General response:

We greatly thank the anonymous reviewers for their comments and suggestions to help improve this manuscript. Both reviewers showed interest in the monitoring results of DSS but commented on the modeling work for relating the strain changes to pore pressure and formation permeability using a hydraulic diffusion model. We first give a general response as follows.

Figure 1. Observed and simulated (a) water head and (b) vertical strain (ϵ_{zz}) in Lei et al. (2019)

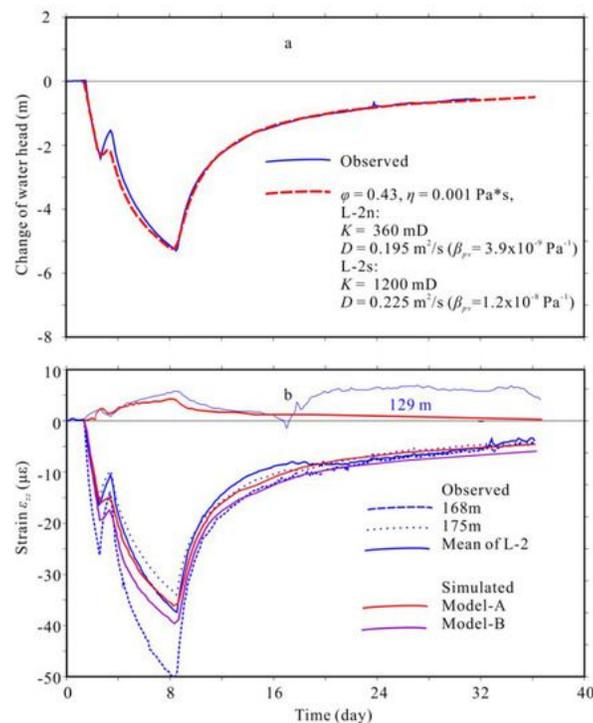
2. In terms of how that deformation informs the local permeability structure, I am reluctant to accept the results from the modeling performed here as a definitive demonstration for two main reasons: First, the authors glance off the strong possibility of bias from an unmodeled skin effect, even though this is a known source of permeability heterogeneity; thus, they simply haven't tested whether the estimates they've obtained (or the variability between the two sampling locations) are representative of the layered system and not just related to wellbore damage and mud infiltration.

Second, it is perplexing why the authors convert the strain signals to "pressure" in order to use simplistic radial flow models. Unless the timescale of the signal is so short as to cause the system to respond like an undrained medium, strain is not simply proportional to pressure in a fully coupled poroelastic medium (not just the one way coupling they mention). This begs the question: what does this approach offer aside from introducing a whole new set of assumptions that may not hold at such a fine scale? Of course there are very simple yet powerful models of the deformation response in a poroelastic medium that could be used (e.g., Rudnicki, 1986, [https://doi.org/10.1016/0167-6636\(86\)90042-6](https://doi.org/10.1016/0167-6636(86)90042-6)); using them would permit a way to model strains directly and also remark on the distribution of pore pressure changes. A more sophisticated to replicate the apparent effect of layer contrasts is also warranted.

Although the experimental part of the manuscript is innovative and nicely described especially the application of the Rayleigh spectrum for strain measurement, the numerical part of the manuscript is trivial. The authors had tried to explain the hydromechanical responses in the observation boreholes using a simple diffusion model without considering the mechanical effect induced by drilling and rather considering only pressure propagation as the driving force for the strain variation.

In an earlier study (of our group), Lei et al. (2019) have shown the corresponding changes between strain and pressure signals in a pumping test at the same field (Figure 1). They further performed both an analytical hydraulic diffusion model, and a coupled hydromechanical model to explain the aquifer hydromechanical parameters, such as permeability and compressibility. Both models can give a reasonable range of permeability changes and can explain measured pressure and strain changes. The first-order strain changes were linearly related with pore pressure changes and can be interpreted using the hydraulic diffusion model. (We will elaborate this discussion in the revision.)

Therefore, in the current study, we use the hydraulic diffusion model under the first-order approximation, and assume a linear relationship between strain and pressure changes with local compressibility (or storage coefficient) to consider the elastic response to pore pressure because we do not have good constraints for the other elastic constants. Moreover, the simplification with the analytical model makes it possible to match the strain or pressure curves by solving an optimization problem. Though the mechanical effect may exist, in a sense of first-order approximation, the analytical results suggest that the trend and pattern of strain changes can be explainable by the hydraulic diffusion mechanism--the main physics.
